THE PARLIAMENT OF THE COMMONWEALTH OF AUSTRALIA
PARLIAMENTARY STANDING COMMITTEE ON PUBLIC WORKS

REPORT
relating to
CONSTRUCTION OF NEW COMMONWEALTH OFFICES,
HAYMARKET, NSW

(Fifth Report of 1988)

**CONSTRUCTION OF NEW COMMONWEALTH OFFICES,
HAYMARKET, NSW**

FIGURE HERITAGE ELEMENTS ON AGL SITE

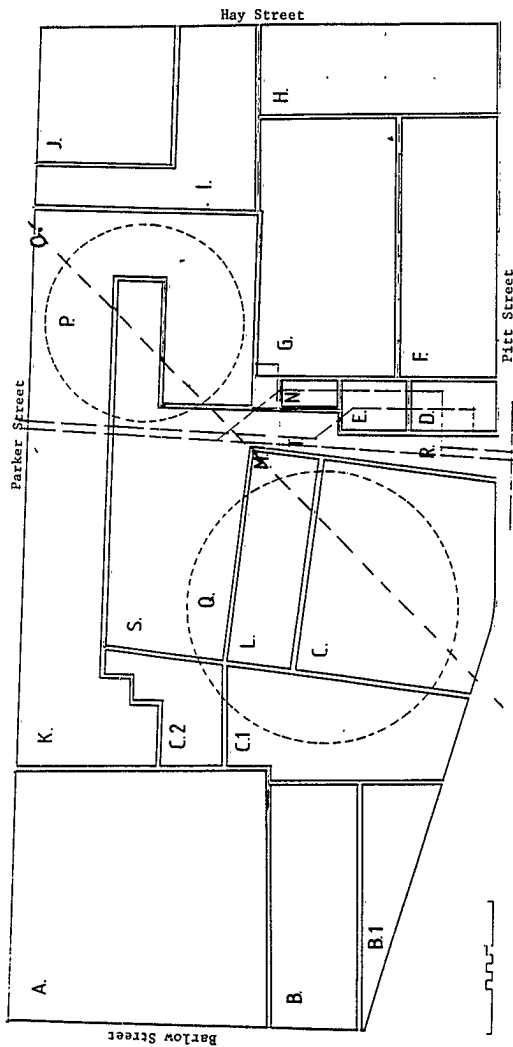
44. Heritage groups do not support DAS's assessment of the conservation of the area and have argued for the retention and/or recording of additional heritage elements on the site. The elements that each group would like retained or recorded are outlined in Appendix C. The heritage elements involved are the Austen Building and AGL Engineers Building (particularly their facades), Anthony Hordern Building, smaller gasholder, AGL Main Hall Annex, Wesleyan Site Shops and the AGL Meter Room.

- . includes in the recording and archaeological study of the site the Meter Room behind the Fire Engine House and the smaller gasholder and any other items found to be of archaeological value;
